**CITY OF MANHATTAN BEACH  
DEPARTMENT OF COMMUNITY DEVELOPMENT  
MEMORANDUM**

**SUBJECT: JUNE 6, 2017 CITY COUNCIL MEETING AGENDA ITEM 18:**

1. Public Comments Regarding Conditions of Approval and Draft Resolutions, and Staff Responses;
2. Link to Environmental Documents

Subject: **Paragon bank setback is a dangerous traffic vision obstruction at 6th street**

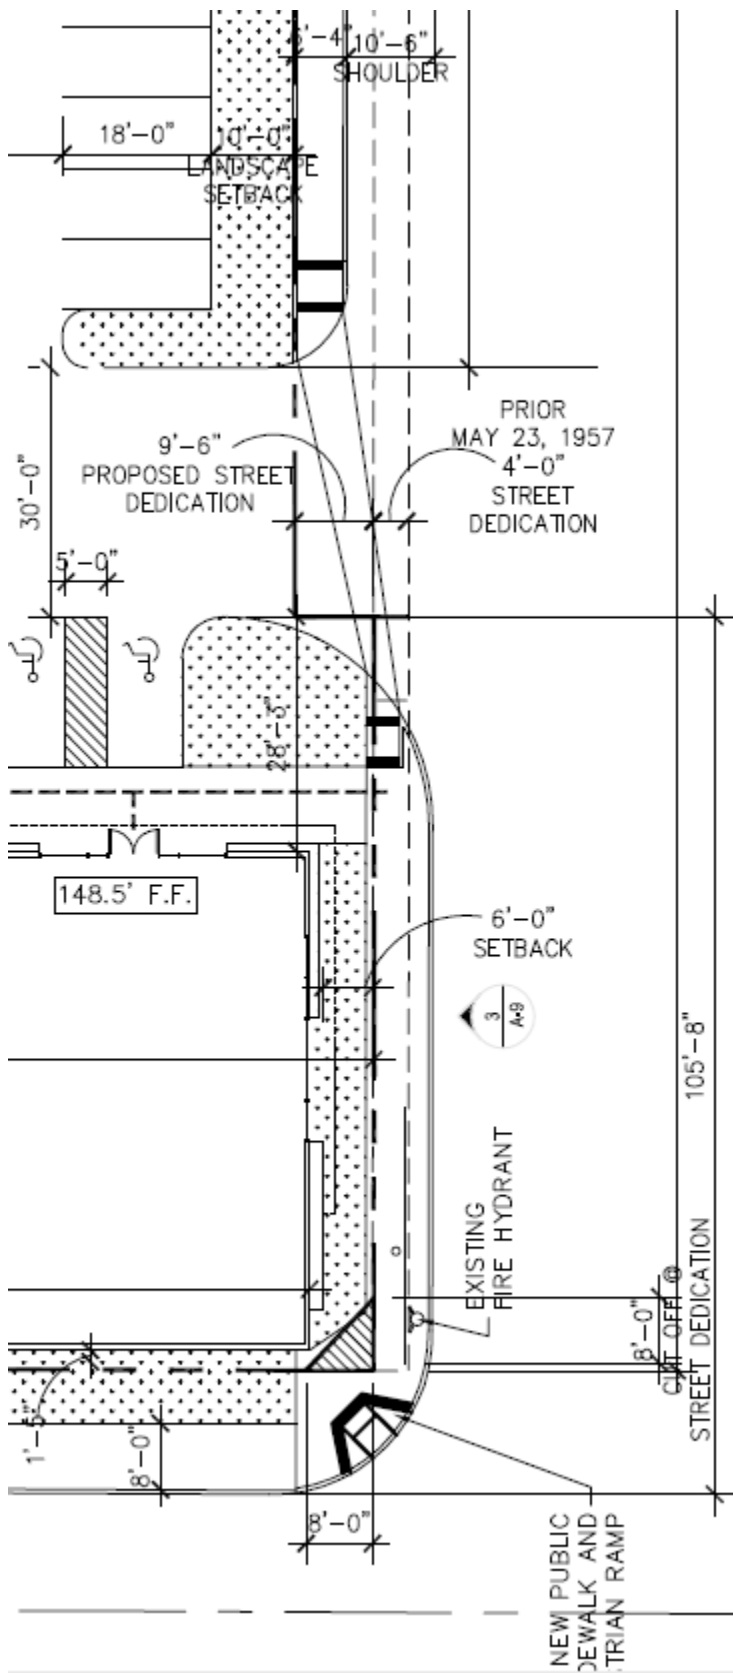
The current 6<sup>th</sup> street entrance onto Sepulveda has unobstructed view north of approaching southbound traffic for the entire 380 feet in front of the Paragon building site. The new bank building in the Paragon plan at the northwest corner of 6<sup>th</sup> street and Sepulveda Blvd is setback 13 feet from the edge of the Sepulveda curb. That distance is the minimum distance as specified in the **MB Sepulveda Development Guide**, August 11, 1999, page 12 and 13. However, drivers entering Sepulveda from 6<sup>th</sup> street will have an obstructed view of the approaching southbound traffic in order to safely enter to turn left or right on Sepulveda. Only by positioning their vehicle very close to the edge of Sepulveda will the driver be able to get a clear view of the oncoming traffic in the entire 380-foot approach from 8<sup>th</sup> street.

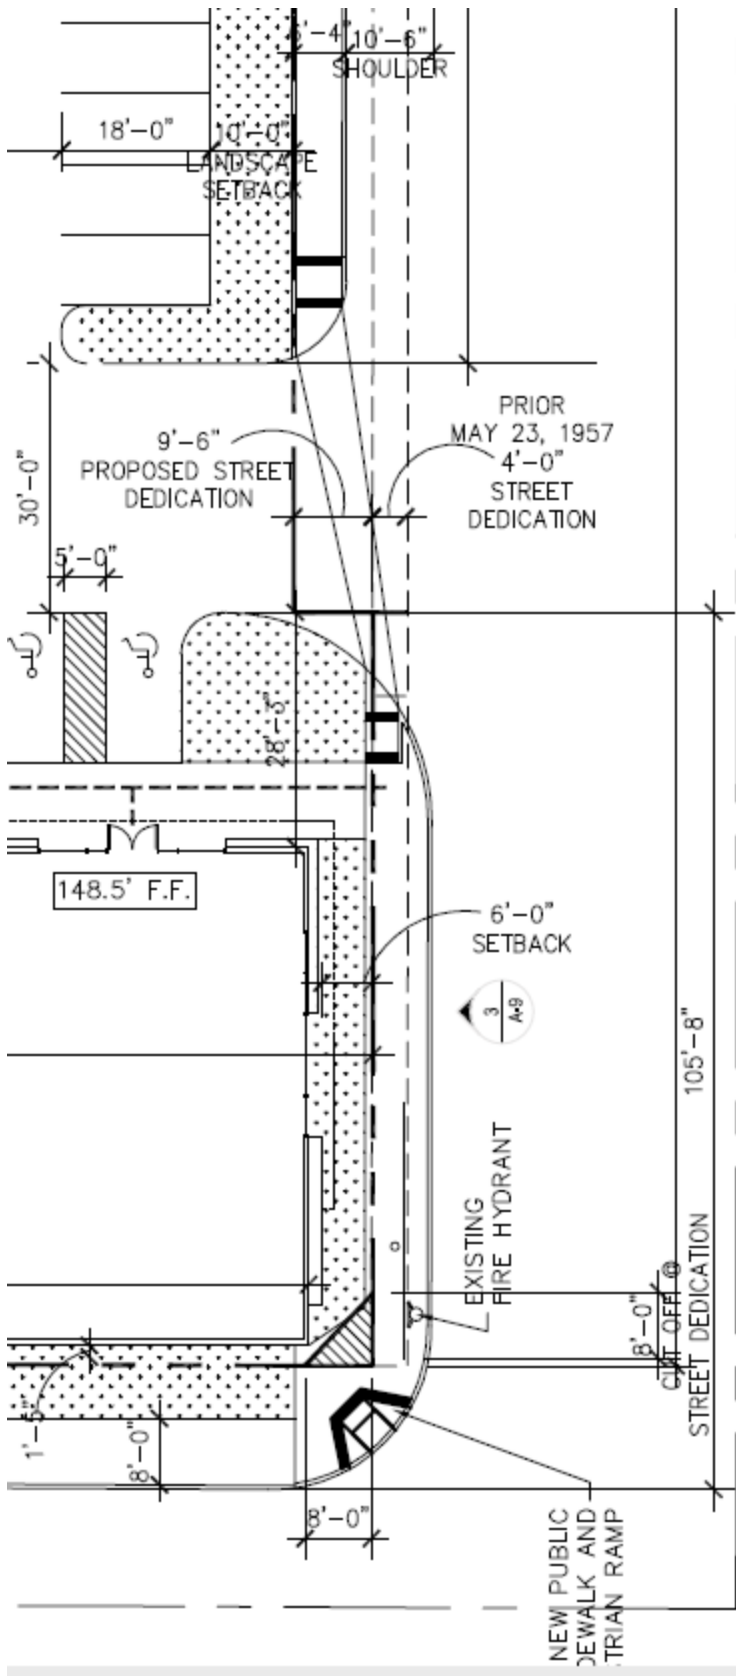
The current 6<sup>th</sup> street entrance onto Sepulveda has unobstructed view north of approaching southbound traffic for the entire 380 feet in front of the Paragon building site. The new bank building in the Paragon plan at the northwest corner of 6<sup>th</sup> street and Sepulveda Blvd is setback 13 feet from the edge of the Sepulveda curb. That distance is the minimum distance as specified in the **MB Sepulveda Development Guide**, August 11, 1999, page 12 and 13. However, drivers entering Sepulveda from 6<sup>th</sup> street will have an obstructed view of the approaching southbound traffic in order to safely enter to turn left or right on Sepulveda. Only by positioning their vehicle very close to the edge of Sepulveda will the driver be able to get a clear view of the oncoming traffic in the entire 380-foot approach from 8<sup>th</sup> street.
